**RE: Family Dollar Store / 4<sup>th</sup> St. NW**  
**Grading Plan and Drainage Report**  
**Stamp Date: 4/28/17**  
**Hydrology File: H14D107**

**RE: Family Dollar Store/4<sup>th</sup> St. NW  
Grading Plan and Drainage Report  
Stamp Date: 4/6/17  
Hydrology File: H14D107**

This letter is in response to your comments by letter dated April 18, 2017. The comments have been addressed as follows:

**A1 GRADING AND DRAINAGE PLAN**  
SCALE: 1"=20'

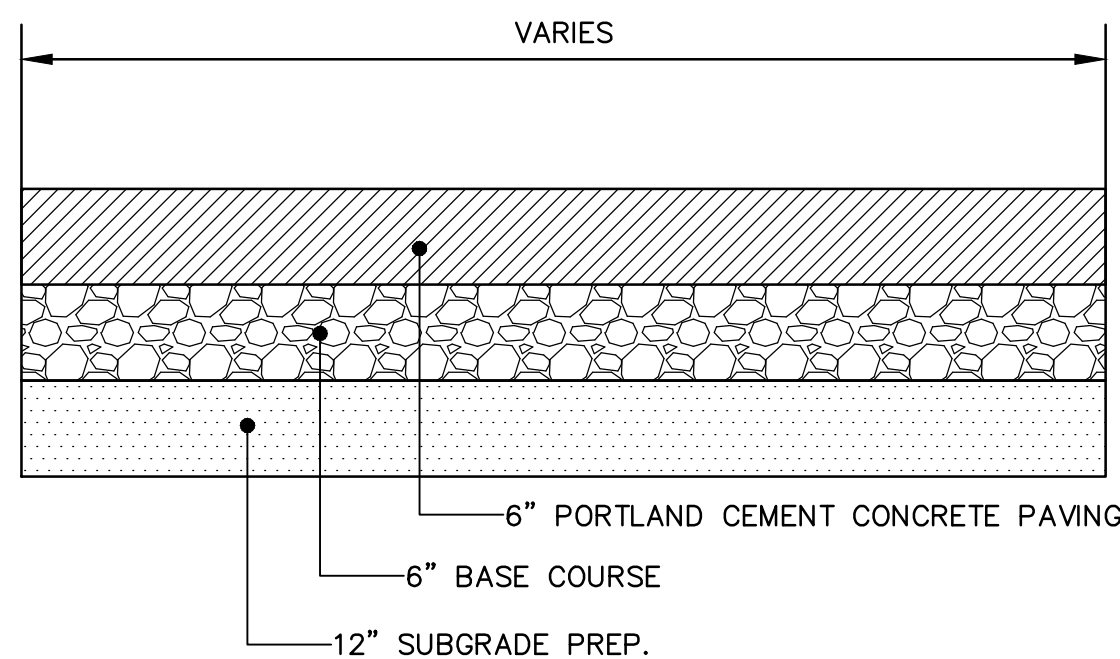
3. Please provide the flowlines for all the proposed concrete channels at both ends (the roof drain and the outfall).

4. Please provide the toe elevations for the proposed rip rap rundown.

5. Under Keyed Notes #18, the invert elevation is stated as 60.0. However, the exiting harvest area has a top elevation of 66.0 and the pond is 3.5 depth, so shouldn't the invert elevation be shown as 62.5 instead of 60.0?

6. Under Keyed Notes, there are two #18s. Please renumber the last five numbers and also change the corresponding numbers on the plan.

7. Please provide the flowline elevation of the start of the proposed valley gutter.

8. Please provide the existing flowline elevation of the existing concrete channel where the proposed valley gutter will connect.

9. Please provide the TC & TA for the corner of the proposed parking near the existing concrete rundown.

10. It appears that the above proposed parking corner is over the existing concrete rundown. If this parking spot is needed, then the existing concrete rundown will have to be replaced or relocated to avoid the construction conflict. Please clarify.

11. Please provide the top and bottom elevation on the shown contours of the existing water harvest basin.

*Spot elevations have been provided at both ends of the concrete channels.*

*Spot elevations have been provided at the toe of the rip rap rundowns.*

*Spot elevations have been provided for the top of pond elevation and the bottom of the pond elevation based on the as-built survey. Keyed note #18 has been updated to reflect this information.*

*This has been corrected.*

*A spot elevation has been provided at this location.*

*A spot elevation has been provided at this location.*

*A spot elevation has been provided at this location.*

*The site plan has been modified.*

*Spot elevations have been provided for the top of pond elevation and the bottom of pond elevation.*
